**PLANNING COMMISSION
SITE PLAN – COMPATIBILITY VARIANCES ONLY**

CASE NUMBER: SP-2021-0102C **PC HEARING DATE:** May 24th, 2022

PROJECT NAME: 1400 Cedar Ave

DESCRIPTION OF WAIVER:

4 Building A&B West Elevation
1/8" = 1'-0" A2.00

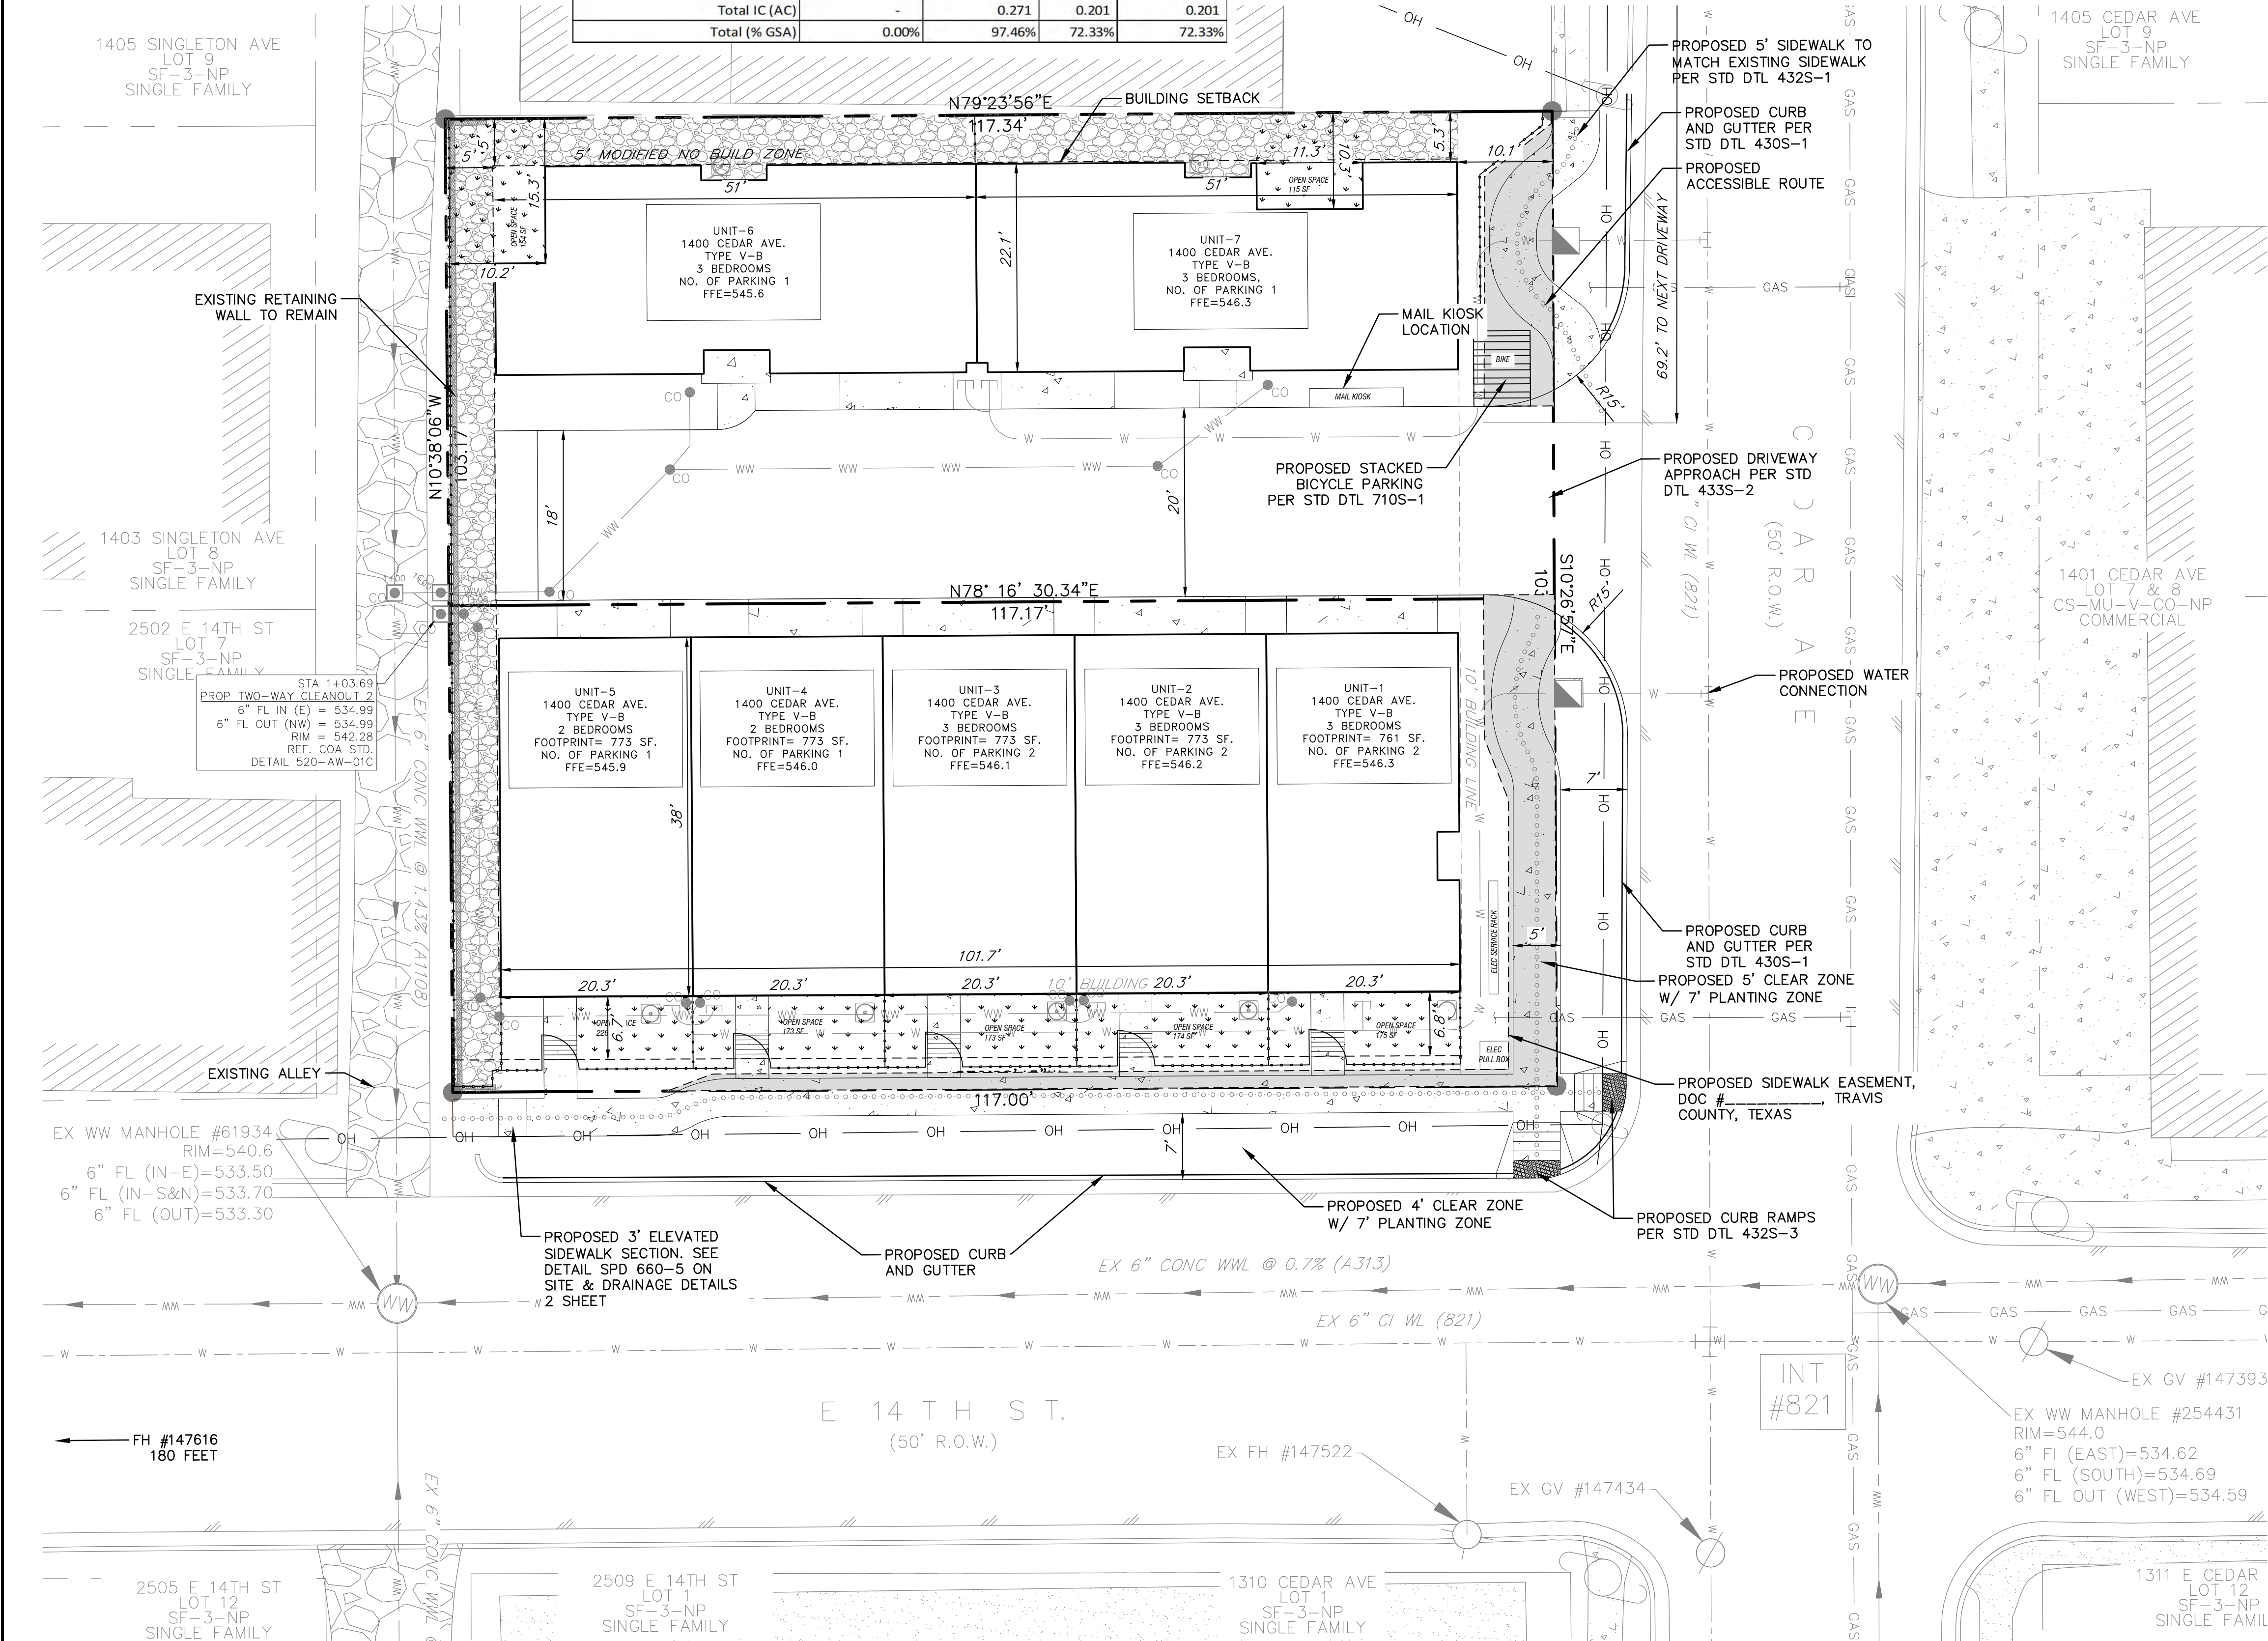
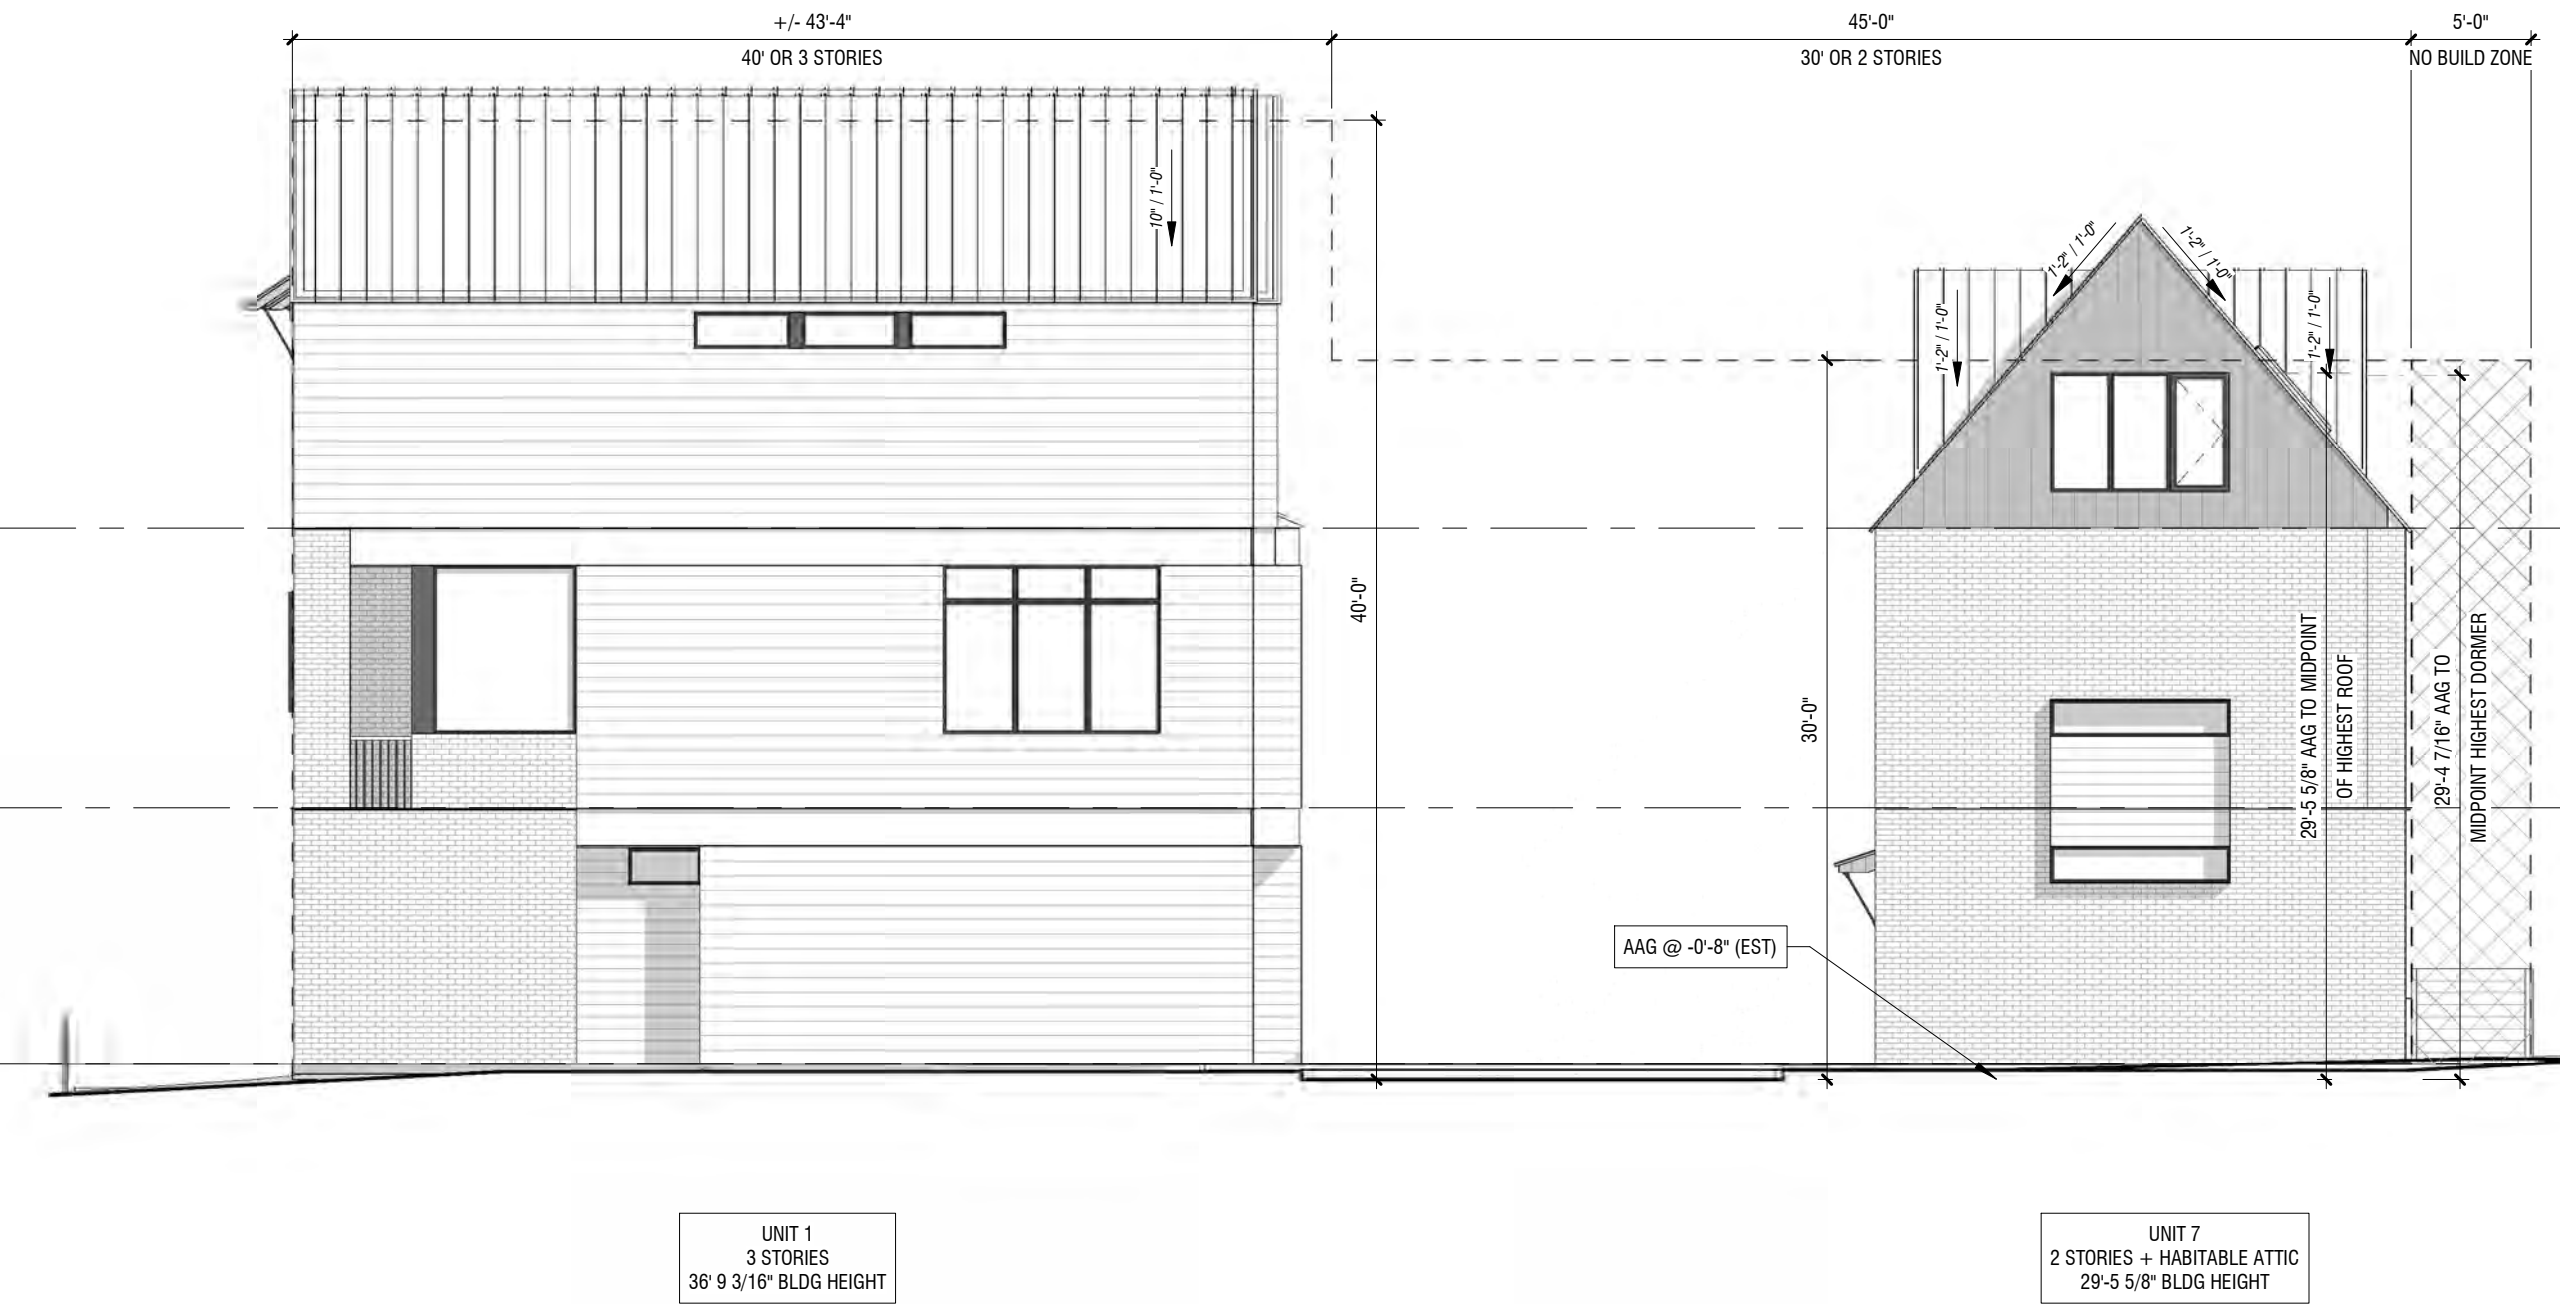
We would like to request that the compatibility standards are modified to reduce the no build zone from 25' to 7' from the SF-3 property located north to this site, and 25' to 18' from the eastern SF-3 property. Attached to this letter is the proposed building elevations sheet.

Hi Zack- Thanks for the explanation. As for the height, the exhibit seems to clearly show that they are exceeding the compatibility tent- see below. What am I missing? Thanks,

You are correct that this waiver is only for compatibility setbacks. The proposed development complies with the compatibility height regulations - this is shown in the background materials. I do realize that it's fairly nitty-gritty so let me know if you'd like to have a call to discuss it in more detail.
